McCULLOCH CORPORATION
SERVICE BULLETIN

1555

MODEL: Super 250, Super 550

SUBJECT: CLUTCH GUARD CLEARANCE

Figure 1.

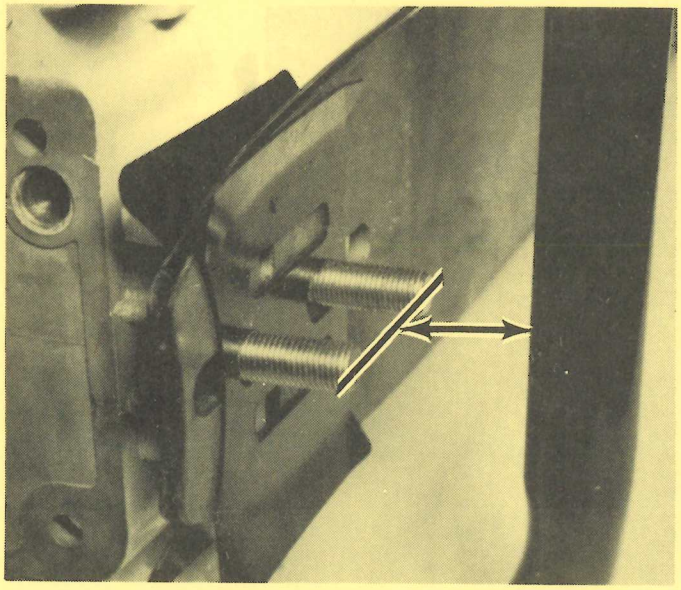
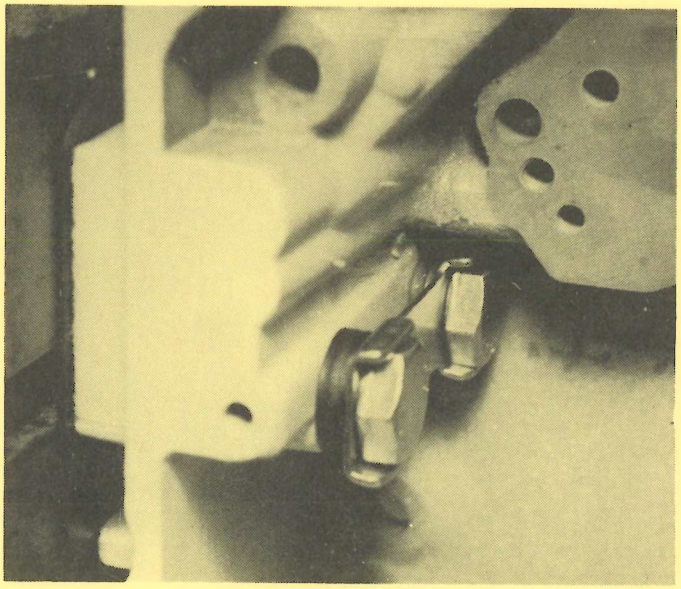
Lower frame screw holes are slightly mis-aligned in some of the frames used on Super 250 and 550 saws. This results in the outer frame arm being too close to the ends of the bar mounting bolts for removal or installation of the guard. See Figure 1.

Wherever necessary to correct this spacing problem, we have installed two Washers, P/N 84623, under each of the two bar mounting bolt heads as shown in Figure 2. Note that the washers are placed under the lockplate.

When making a bar bolt replacement on one of these installations, be sure to reinstall the washers as illustrated.
